The regular meeting of the Planning Board convened at 6:30 pm in the Council Chamber room.

COPART SPECIAL PERMIT/SITE PLAN PUBLIC HEARING

TRINITY CIRCLE PUBLIC HEARING CONTINUATION

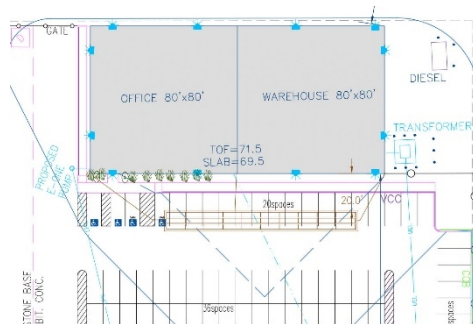
*"I have completed my review of the site plan and stormwater management report submitted with the application for a site plan and special permit approval by the Planning Board. The site plan and the stormwater management report are both dated December 29, 2016 and were prepared by Silva Engineering Associates, P.C. (SEA). I've also reviewed a bound document titled: "Environmental Responsibility Making a Difference Copart Inc. 2016". In light of prior meeting discussions with representatives of Copart, and as a result of my review of the above noted documents, I offer the following comments and/or recommendations: **1**, the stormwater management report includes recharge volume computations for the paved portion of the site based on the use of "Cultec R-150XLHD (Cultec Recharger 150XLHD)" system but the site plan does not reflect the use of the system. The site plan needs to be harmonized with the stormwater management report; **2**, the use of gravel surface is proposed for the majority of the 20+ acre area where the vehicles are to be stored. Gravel surfaces are conducive for runoff control and infiltration but the use of limestone as noted on the "storage yard" detail on plan sheet C.3.0 is not desirable as it has binding properties and would function as a paved surface, in which case, stormwater runoff from the area should be treated as runoff from a paved surface, and treatment volume computation consistent with the DEP Stormwater Management Handbook should be provided. If gravel surface is to be used, specifications for a pervious gravel surface should be included. The applicant noted at the February 1, 2017 public hearing meeting that snow plowing will not be required because the "fork lifts they use for storing and retrieving vehicles from the platforms can be operated over snow; therefore, it does not appear that the finished gravel surface grades would be impaired by snow plowing operations; **3**, given the size and scope of the proposed site use, Elm Street which is already in serious disrepair would be subject to additional and incalculable repeated volumes of heavy traffic wheel loads that would exacerbate the poor condition of the road. As part of a special permit condition, the Board should require the applicant to provide mitigation fund that would go towards improving Elm Street; **4**, the document titled: "Environmental Responsibility Making a Difference Copart Inc. 2016" should be revised, and tailored specific to the site as an Operation and Maintenance Manual for the proposed facility, and shall bear original wet ink seals and signatures of Massachusetts Registered Professional Engineer and Licensed Site Professional responsible for preparing the document. The manual should include emergency response protocols for handling, containing, and disposing vehicle fluid spills consistent with the Massachusetts Contingency Plan (MCP), 310 CMR 40, including the names, addresses, and phone numbers of in-state agents and representatives of the firm*

Comment 1- The CAD layer was inadvertently “turned off” prior to printing the site plans. The sketch below shows the location of the proposed roof infiltration chambers and will be incorporated on the final set of plans.
